**GEOTECHNICAL EVALUATION OF ERVEN 549, 550 AND 551,**  
**CHAPMANS PEAK ESTATE, NOORDHOEK.**

**1. TERMS OF REFERENCE AND BRIEF**

It was requested by Mr. D. Jeffery of Doug Jeffery Environmental Consultants by way of an e-mail dated 31/10/17, that geotechnical comment be passed on the proposed changes to the site development plan for Chapmans Peak Estate, Noordhoek.

**PROPOSED NEW OFFICES AND REVISED RESTAURANT SITE PLAN LAYOUT**

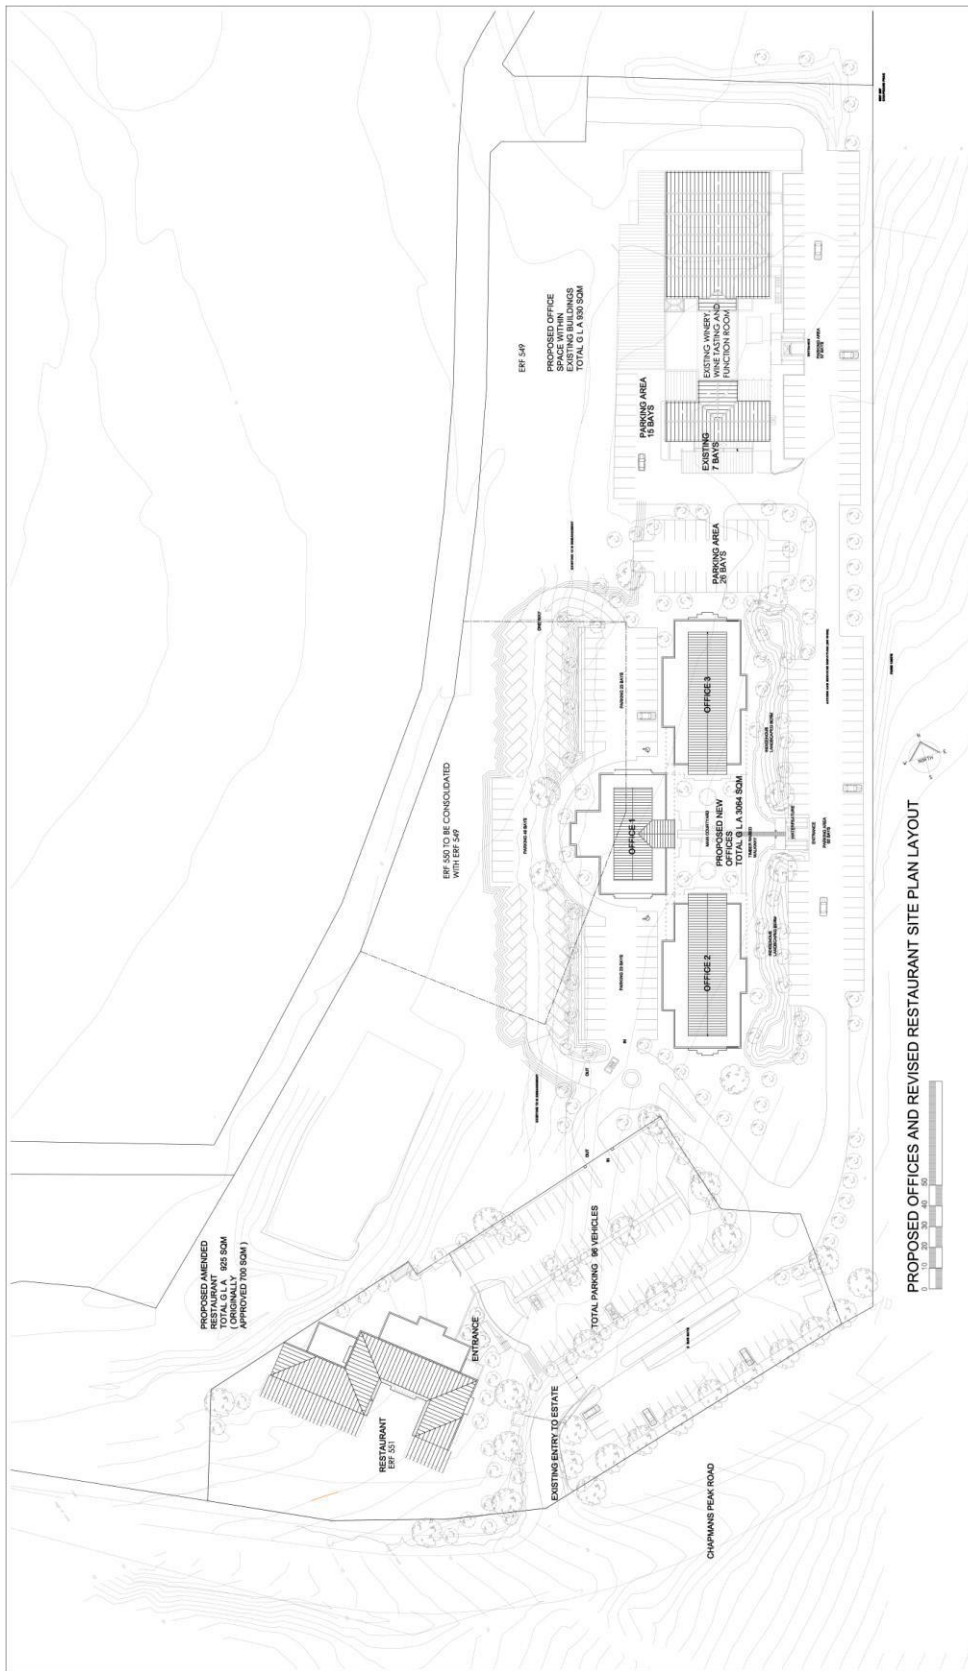
However the platform for the restaurant on erf 551 is shown as cutting into the slope below the dam or detention pond, and into the toe of its wall. This is likely to result in:-

- A reduction in the factor of safety of the stability of the dam wall to an unacceptably low level or to the point of possible collapse with devastating consequences to the restaurant and its patrons.
- Significant groundwater flows as leakage from the dam, egressing in the cut faces and floors below. These could cause collapse of cut faces and retaining walls and pose problems in terms of movements of foundations to structures and paved areas.

It is suggested that the dam be relocated to the west so as not to lie above the restaurant area or that it be investigated and analyzed in detail and lined so as to eliminate sub-surface leakage. Such an investigation might lead to the conclusion that the wall needs rebuilding prior to the dam being lined.

Other than the concerns relating to the dam and which it is understood are to be addressed by conducting a detailed stability analysis of its wall and if proved necessary, lining it and or modifying the wall, there are no other significant geotechnical issues apparent which oppose the proposed changes to the SDP.
